FLOOD CONTROL
DISTRICT OF
MARICOPA COUNTY

**Arizona
Canal Diversion Channel
Reach 4
Letter of Map Revision**

REVISION REQUESTOR AND COMMUNITY OFFICIAL FORM

3. Project Name/Identifier: ACDC Reach 4

MAP NUMBER
04013C1655 F

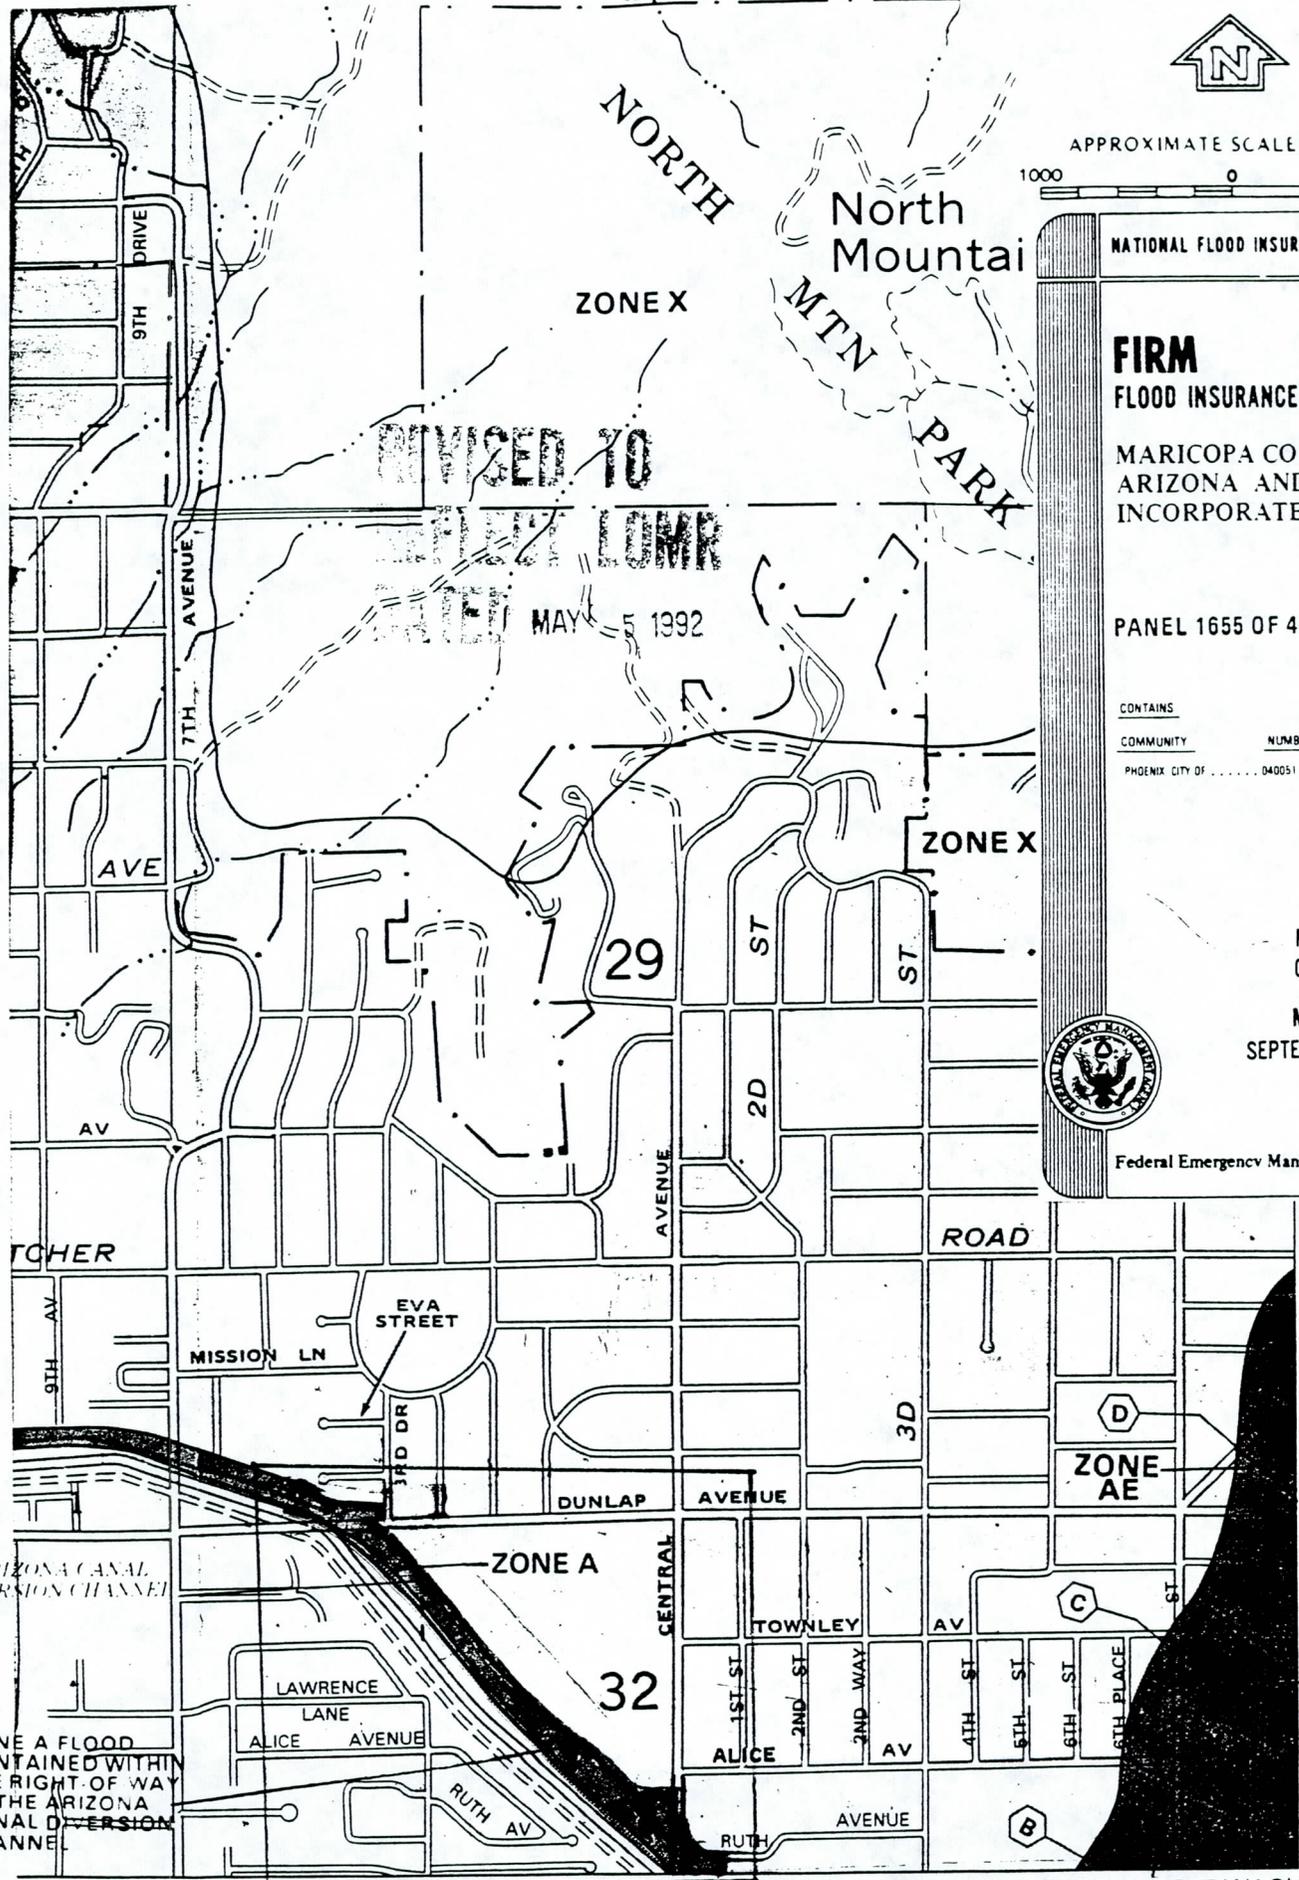
AREA REVISED

FLOODING EFFECTS FROM TENTH STREET WASH

MAP NUMBER
04U13C1665 E
MAP REVISED:
SEPTEMBER 4, 1991

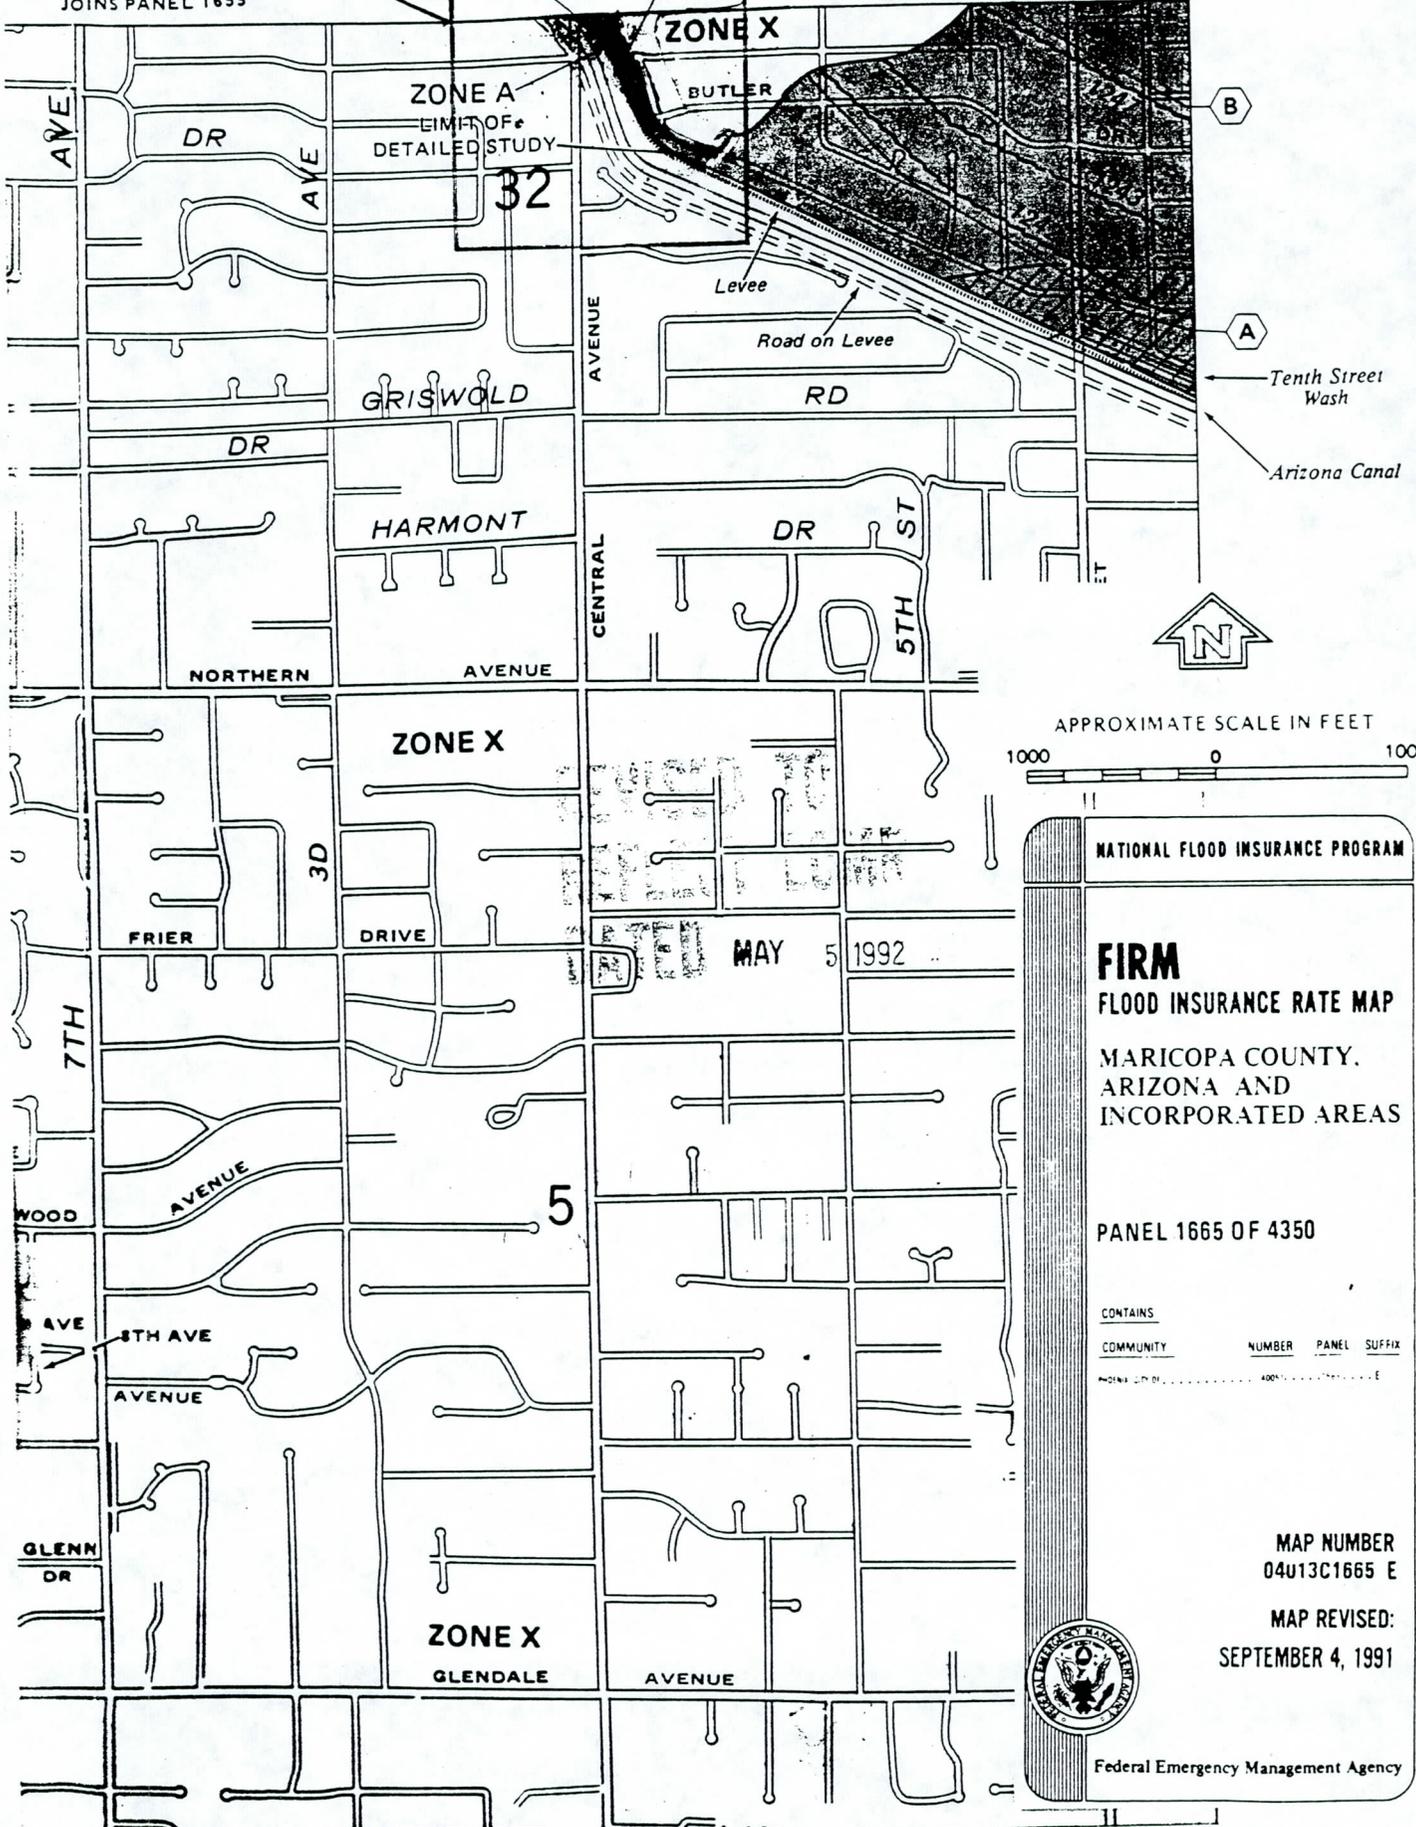
ZONE A FLOOD
CONTAINED WITHIN
THE RIGHT-OF-WAY
OF THE ARIZONA
CANAL DIVERSION
CHANNEL

ARIZONA CANAL
DIVERSION CHANNEL

AREA REVISED
